<b>Planning and Zoning Commission</b>  <b>STAFF REPORT</b>	<b>AGENDA</b>  # _____
---	--	------------------------------

**TO:** CASA GRANDE PLANNING AND ZONING COMMISSION  
**FROM:** James Gagliardi, AICP, City Planner  
**MEETING DATE:** September 1, 2016

1. **DSA-16-00074: Preliminary Condominium Plat**, re-platting Lot 1 Tanger Outlets into 42 condo suites and a common tract for parking, landscaping, drainage, access, and utilities.

Exhibit C- Proposed Preliminary Condominium Plat

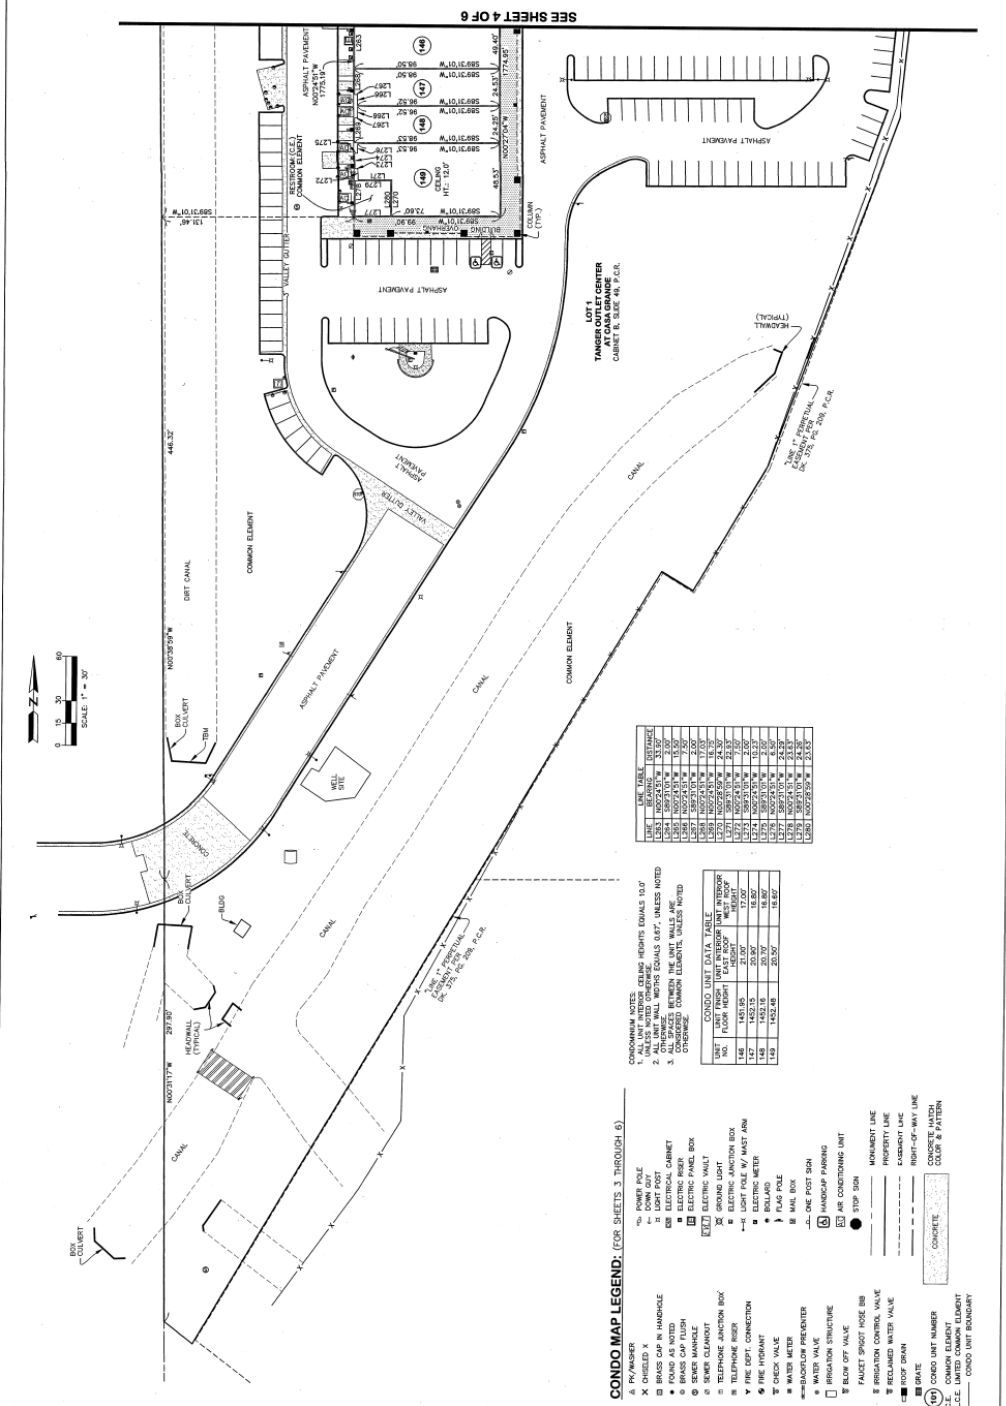
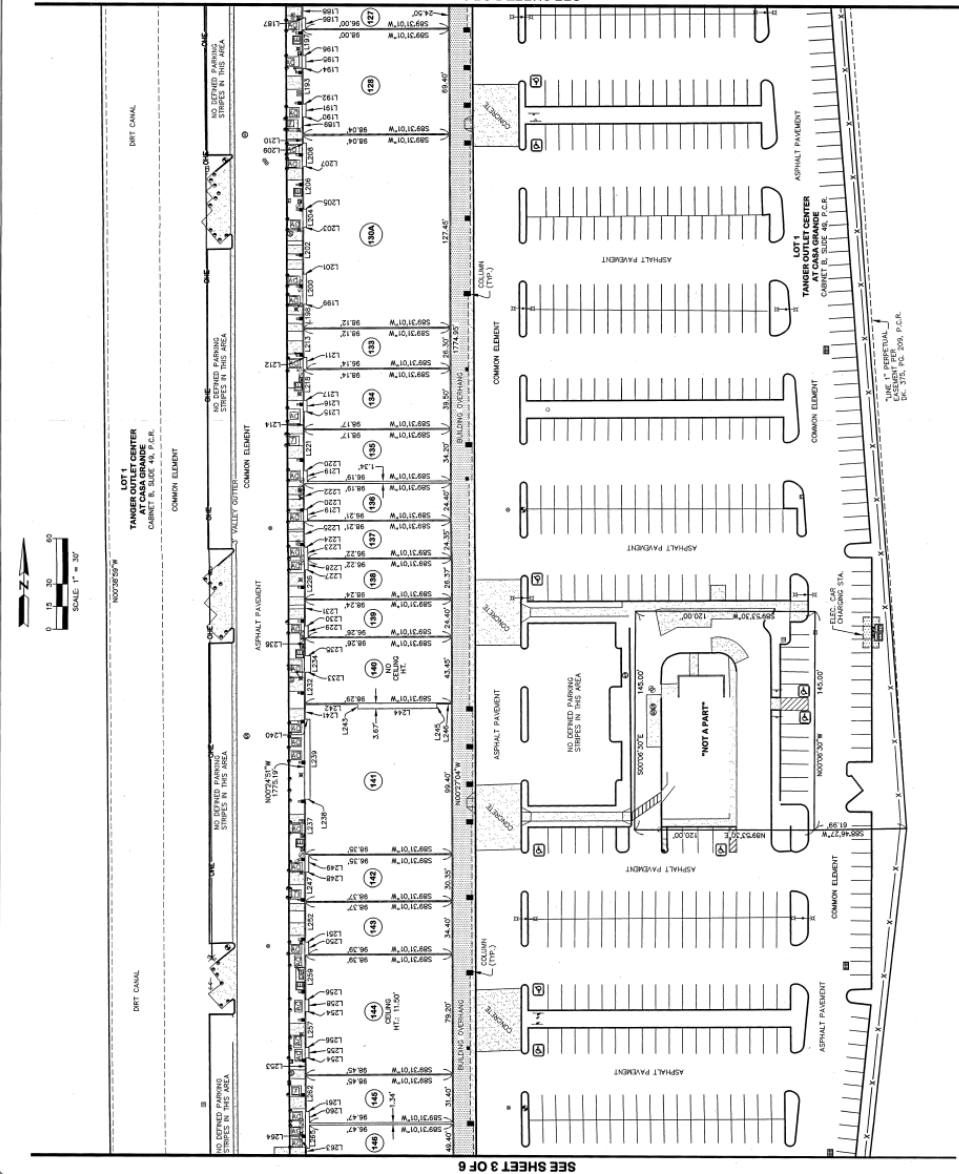
1. Provide access to electrical room #108 without entering a tenant space for 24-hour direct access.
2. Show access to electrical rooms within details A, B, and C.
3. Show fire-riser rooms
4. Specify if Fire Sprinklers are common elements or contained-in and owned by each unit.

1. Provide a statement on the plat that discusses who is going to have the responsibility for the Fire Sprinkler Systems, Fire Alarm Systems and the Fire Hydrants and the fire main underground system for the property.

2. Confirm that all existing fire protection system are being tested, inspected and maintained per the NFPA requirements for each system (NFPA 72-Fire Alarm System, NFPA 25- Fire Sprinkler System, and NFPA 25—Fire Hydrants and Fire Main Underground.

3. To ensure Fire Department access to all common areas and any areas where there are fire sprinkler risers and fire alarm panels, existing Knox Boxes be used for the common areas access keys. If individual tenant owners would like to have their key in a Knox Box so that the Fire Department can gain entry, they shall purchase and install their own Knox Box. It is suggested that the master key system is controlled by an association.

1. This is a replat of Lot 1 of Tanger Outlets at Casa Grande recorded at cabinet 000B, page 0049. The legal description should indicate this as a "replat" of such. The legal description as written appears to only be for a "portion" for lot 1, which is true, since the Wendy's parcel within Lot 1 is to be excepted from the platting of the condominiums, but it appears that the legal description is omitting that area of the platted lot that contains Interstate 10 and its off-ramp. If this area is not to be part of the new plat, an exhibit must be provided that shows "as platted" v. an "as replatted" exhibit with a new total lot area to be provided.
2. This resubdivision should specify a specific exception of the Wendy's parcel.

This is to include its legal description that is being excepted.

3. A legal description needs to be provided for the common parking lot, landscaping and drainage elements and under a header for such. The areas of the plat depicting these common elements need to be dimensioned.

4. Provide a summary on the preliminary plat indicating the total number of acres, and total number of condominium lots, and total square footage of buildings. Indicate what percentage of the lot is open space.

5. Provide widths of canals and access drives and drive aisles.
6. Name the canals and drains on the site.
7. A statement shall be provided on the preliminary plat describing who has the responsibility for maintenance of common elements, including building exterior, common areas interior to the building, parking, access ways, drainage basins, drainage basins, signage, and landscape areas, indicating that such shall be subject to CCR's.

8. Provided that Wendy's is on a separate parcel within Lot 1, but to be excepted from this resubdivision. Within the narrative (Exhibit B) it is explained there is an agreement between Wendy's and CityGate allowing parking, access and utility service agreement across CityGate's property; however, a statement and easement shall be provided on this plat to ensure that Lot 1 can be used for utilities, parking and access for Wendy's as well as a specifying what retention basin(s) within the common area is to be used for storm run-off coming from the Wendy's parcel.

1. There is a 65 ft. wide drainage easement dedicated by the previous plat that needs to be identified on this replat. It runs along the western boundary of the subdivision.
2. Specify what basin or basins collect water for the Wendy's parcel, and provide an easement for this.

3. If any run-off from Interstate 10 runs onto the property, specify what basin accommodates for this flow and indicate an easement for such.
4. In the previously approved plat, there was a note regarding the site being subject to undefined irrigation easements. Please replicate.
5. Modify the note regarding the 100 year flood plain to state that a flood elevation certificate may be required for Tenant improvements that meet the FEMA substantial improvement criteria. Tenant improvements that meet the FEMA substantial improvement criteria shall be required to elevate their finished first floor elevation one foot from the base flood elevation or take other appropriate flood-proofing measures.

1. Show all utility service and main lines, and indicate their sizes.
2. Specifically, call out the 15" sewer line runs from the south to the north near the western edge of the lot. There is an existing sewer easement and public utility easement in this same area that needs to be identified. All existing easements need to be identified.
3. In the previously approved plat, there was a note regarding the site being subject to undefined electrical easements. Please replicate and show all other underground utilities.
4. Provide and show an easement for utilities that serve Wendy's across the common area of the adjacent parcel.

The subdivision's boundaries do not abut Jimmie Kerr Blvd, the only means of public access; but rather, Tanger Drive, a private road connects this development to Jimmie Kerr through another parcel, not a part of this subdivision. A roadway easement shall be established and stated on this plat that specifies public access to Jimmie Kerr from the subdivision.

The length of the lot is approximately 3,000 ft. The 40 acres of property only has one public access point. Per Section 16.16.210 of the City Code, the arrangement of streets shall provide for the continuation between adjacent properties when continuation is necessary for convenient movement of traffic, effective fire protection, for efficient provision of utilities and where such continuation is in accordance with the General Plan. Therefore, it shall be a condition that a public access easement be provided along the north boundary that allows connectivity to the parcel to the west and to the north for access from these parcels to Jimmie Kerr Blvd.
